**Re: Artesian Water Company, Inc. Written Public Comments Regarding Delaware Recyclable Products, Inc. Permit Modification Application**

Re: Permit Modification Application of Delaware Recyclable Products, Inc. relating to  
DRPI Landfill, New Castle, Delaware

**ARTESIAN WATER COMPANY, INC. COMMENTS RE  
Permit Modification Application of Delaware Recyclable Products,  
Inc.  
relating to DRPI Landfill, New Castle, Delaware**

Figure 1a, Section of Hydrologic Map Series, No. 3 sheet 1 Basic Geology (Woodruff, 1981)

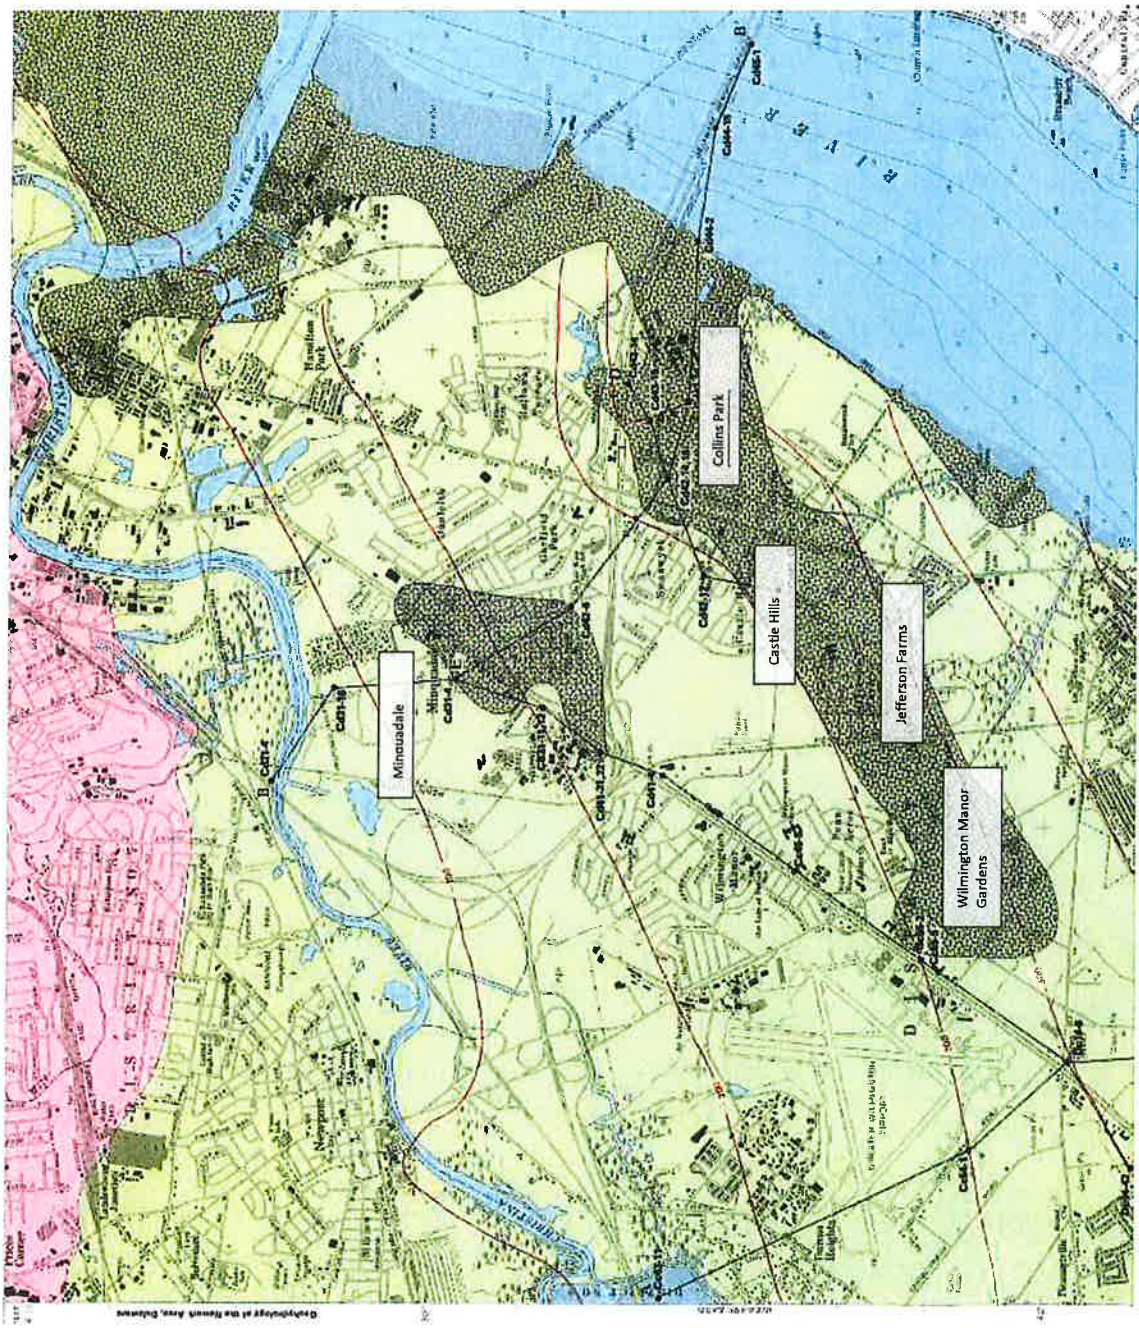
The nature and extent of the Potomac aquifer system has been the subject of Delaware Geological Survey (DGS) mapping in New Castle County. Specifically, the Hydrogeologic Map Series 3 report by Woodruff (1981) addresses this area of Wilmington. Upper Potomac sands are mapable over extended distances in this region of Delaware (see attached Figure 1a and 1b from Woodruff, 1981). The maps and cross-sections illustrate an approximate top of the Upper Potomac aquifer near 0 feet mean sea level (msl) in the Minquadale area. In addition, these maps illustrate the Upper Potomac aquifer subcropping in the Minquadale area (Figure 2a and 2b). This area is an important recharge area to the Upper Potomac aquifer. The map and cross sections (Figures 1a and 1b) also illustrate the relationship of the landfill to the well fields. The

Figure 1b, Cross Section B – B' from Hydrologic Map Series, No. 3 sheet 1 Basic Geology (Woodruff, 1981)

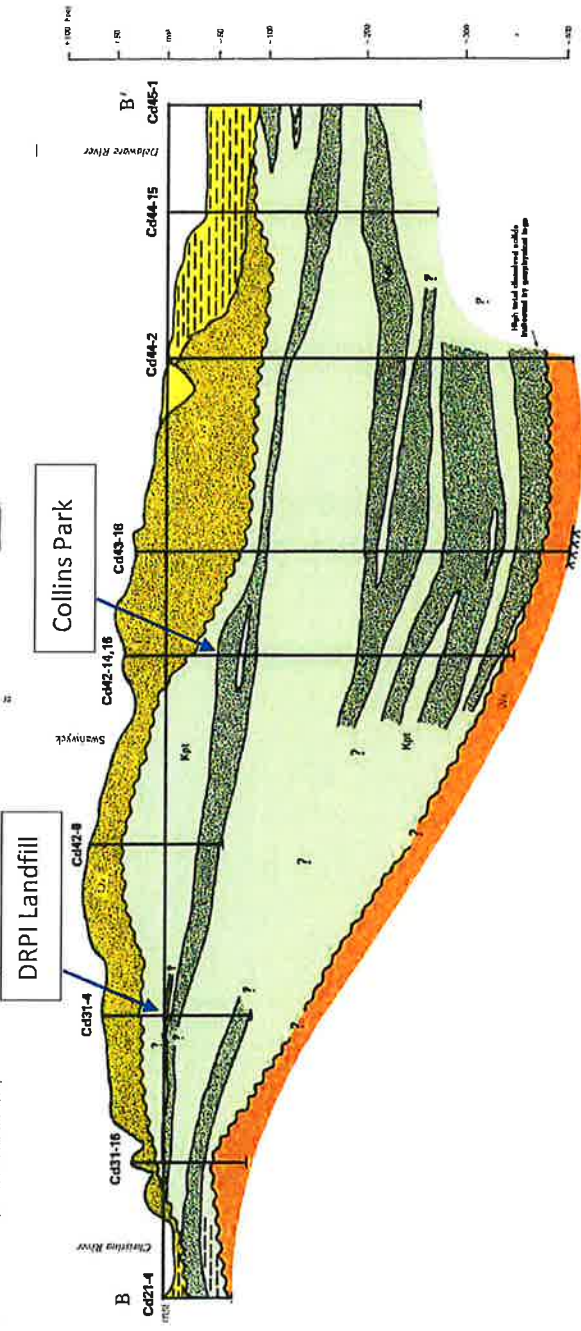
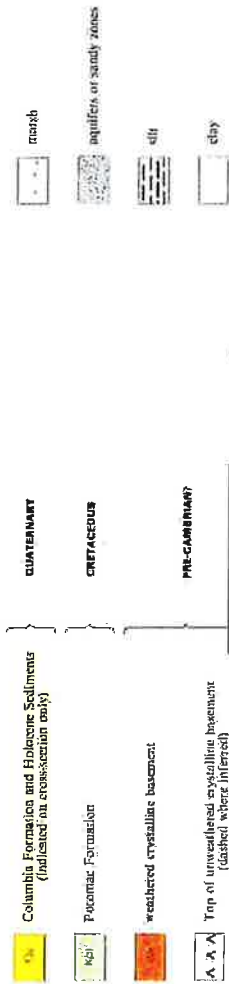
Note: Well Cd31-4 is very close to the Minguadale Landfill and Well Cd42-4, 16 is close to the Collins Park Well Field

**Figure 3, isopach (Thickness) Map of the Columbia Formation**

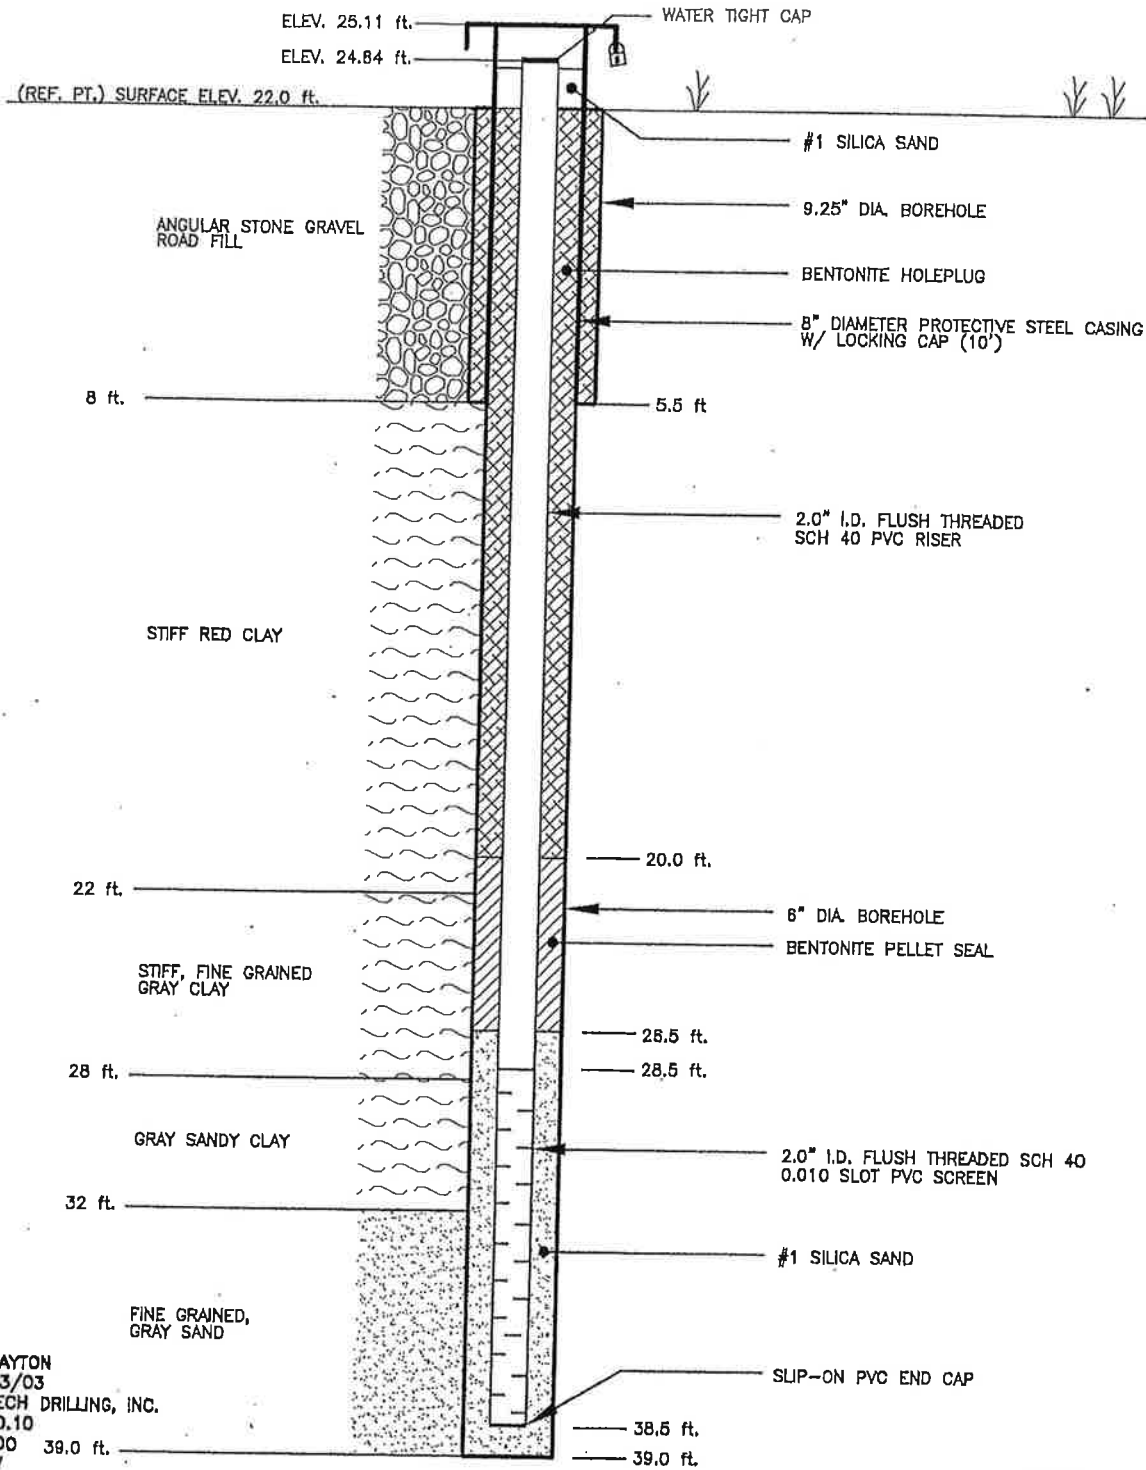
publication "Geology of the Wilmington Area, Delaware (Woodruff and Thompson (1975) illustrate the thickness of the Columbia Formation and shows rapid changes across the DRPI site. (Figure 3). The map illustrates a channel in the Columbia Formation to the southeast of the site that, in places, removed the upper Potomac confining layer (Figure 2b and 3). Basic geologic data illustrate the hydraulic connection of the Minquadale area to critical Artesian Wellfields. These basic geologic and hydrogeologic data with the relationship to public supply water wells are not presented in the HAR document.

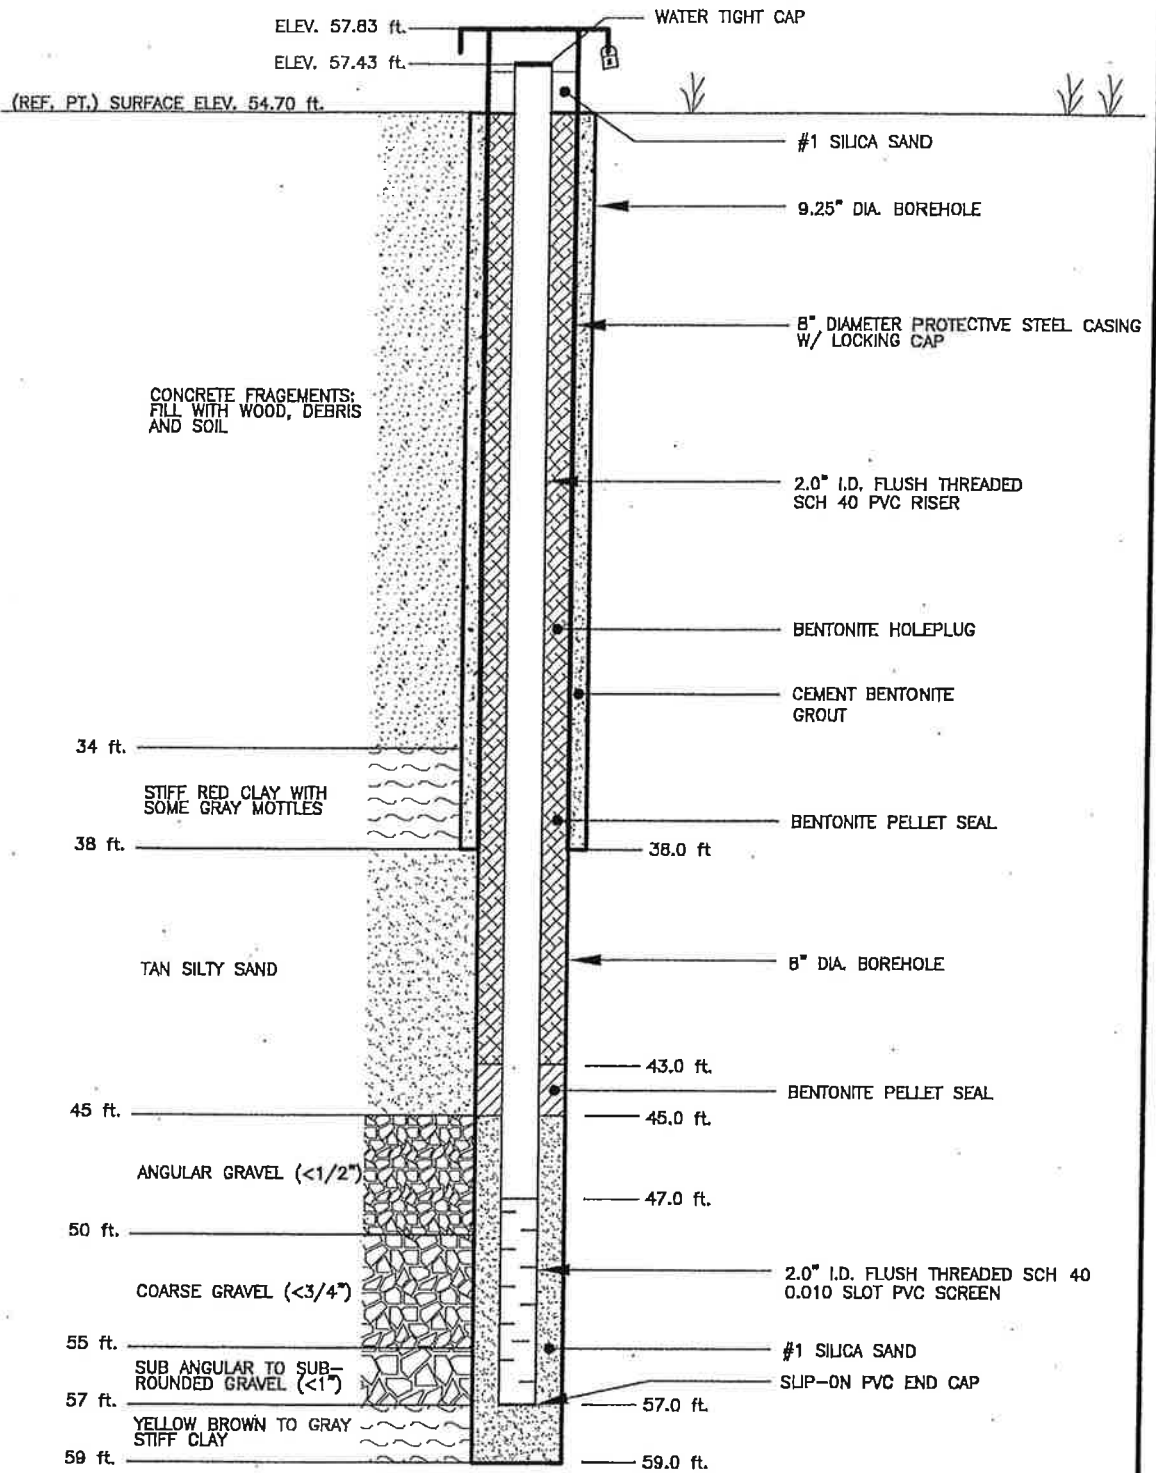
The HAR specifically provides data where the Upper Potomac sand is missing and presumed not to be continuous. One location is well MS-101(S), one of the three wells drilled for the 2004 investigation. First comment is that MW-101(S) is shown to be screened in clay on the fence diagram in the 2004 report (fence diagram within Attachment 1 hereto). However, their graphic log illustrates the well is screened in a sand at roughly 0 feet msl. This inconsistency needs explanation as it has serious implications on hydrogeologic interpretation of the site. Remember, 0 feet msl is the elevation on Figure 1b of the DGS cross sections where the Upper Potomac aquifer is located in Minquadale.

A second question about the MW-101(S) descriptive log is at a depth of 22 – 24 feet. The lithologic description is a "fine-grained clay". By definition, all clays are fine grained. Looking at blow counts and sample recovery, a more likely material is "fine grained sand". The noted elevation of the "fine grained clay" is just above 0 feet msl, the expected elevation of the Upper Potomac aquifer. As stated above, the fence diagram does show the screened interval of MW-101(S) as a clay zone, not an aquifer. But Well MW-101(S) is screened in an aquifer zone. Again, questionable basic data in well logs has serious implications on the conclusions of the report.
